NOTICE OF DECISION

SUBDIVISION TENTATIVE PLAN / CLASS 2 ADJUSTMENT CASE NO.: SUB-ADJ25-02

LOCATION: 4208 and 4258 Market St NE, Salem OR 97301

Summary: A subdivision to create five new lots, including three flag lots.

CORNER OF MARKET AND TIERRA - SUBDIVISION TENTATIVE PLAN

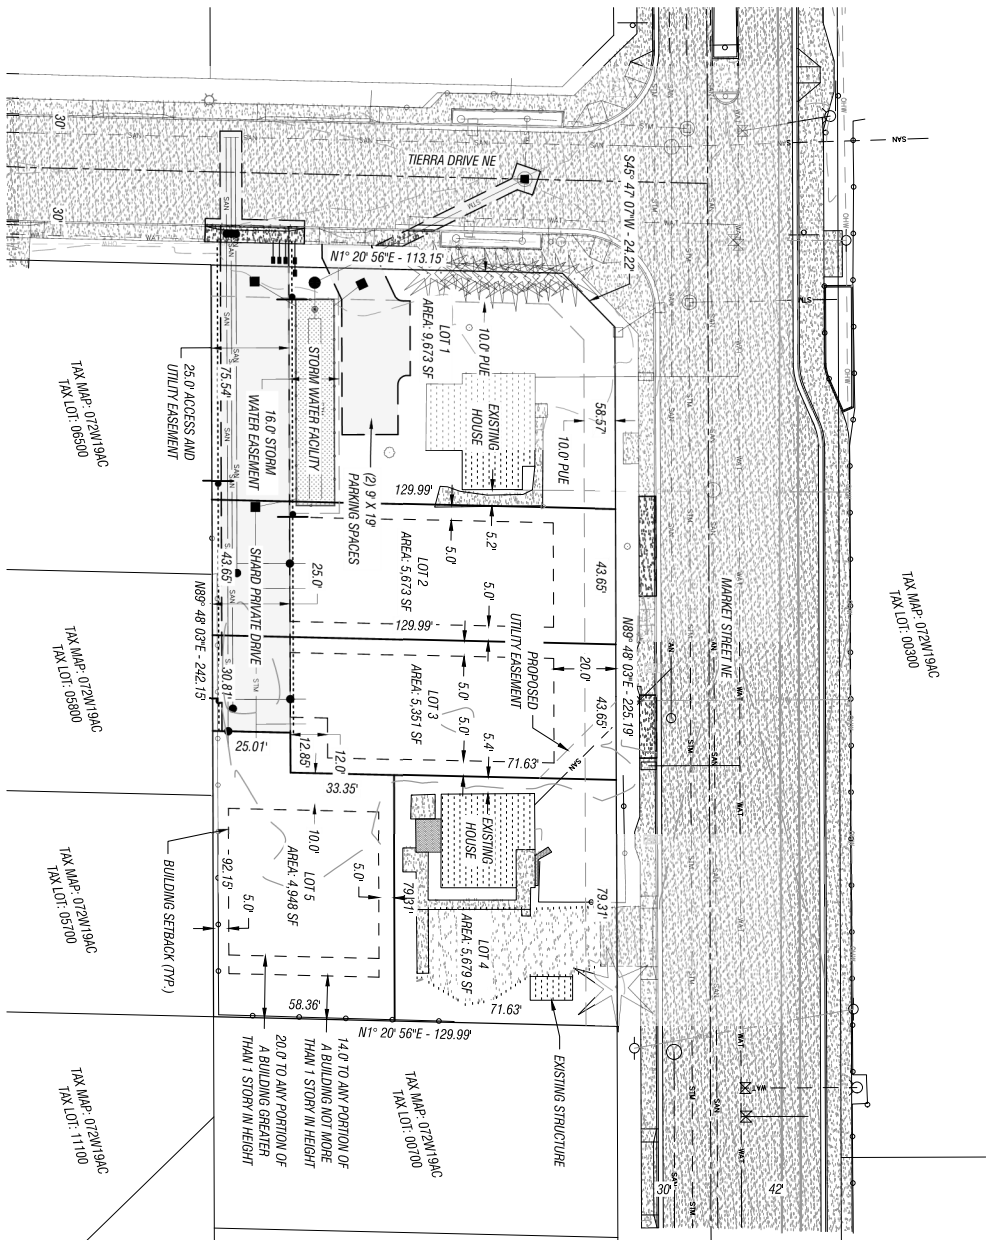
Finding: Lot 5 as proposed on the tentative plan includes a 13-foot extension toward the west where it abuts the terminus of the flag lot accessway. This area of the lot conflicts with the access of Lot 3 onto the flag lot accessway. To ensure this area can be used for access for both Lots 3 and 5, prior to final plat, the applicant shall revise the plan to include this area within the flag lot accessway, bringing the front lot line of Lot 5 in line with the west property line between it and Lot 3.

Finding: The proposal includes one flag lot, Lot 5, with one duplex proposed to be served by the flag lot accessway. The site plan indicates an accessway approximately 150 feet long and 25 feet wide, with 22 feet of paved width. As conditioned above, prior to final plat, the tentative subdivision plan shall be revised so that the accessway is extended 13 feet to meet the front property line of Lot 5. As measured from here, the flag lot accessway will be 163 feet. While only Lot 5 is a flag lot, the accessway is proposed to serve Lots 2 and 3, which are also proposed to be developed with duplexes, for a total of six units. The flag lot accessway is within the maximum 400-foot length of serving three to four units.

Finding: As shown on the applicant's plan, shared access easements are required and utility easements are required where services cross the new property lines. Any easements needed to serve the proposed parcels with City infrastructure shall be shown on the final plat.

Finding: As shown on the applicant's preliminary drainage plan, a common private stormwater system is proposed to serve the subdivision. According to SRC 802.040(c) if the private system serves multiple properties under separate ownership, an agreement between the property owners is required to ensure continued maintenance of the system. To ensure that the applicant shall be required to provide a Private Shared Stormwater Agreement that meets the standards of SRC 802.040, the following condition shall apply.

Finding: The development site is currently served by three driveway approaches onto Market Street NE. As shown on the applicant's plans, two of the three driveway approaches onto Market Street NE will be closed and two new approaches onto Tierra will be constructed to serve both Lot 1 and the flag lot accessway. Per SRC 803.035(c)(1) driveway approaches onto arterial roadways are only permitted to serve approved vehicle use areas. As the approaches are no longer proposed to serve a vehicle use area, the unused driveway approaches onto Market Street NE shall be closed and replaced with curb and sidewalk.

Condition 2: Prior to final plat, revise the tentative subdivision plan so that the front lot line of Lot 5 is a direct continuation of the property line separating Lot 5 from Lot 3.

Condition 11: Prior to final plat approval or delayed pursuant to improvement agreement per SRC 205.035(c)(7)(B), permanently close the two unused driveway approaches onto Market Street NE and replace with curb and sidewalk, as shown on the applicant's plans.
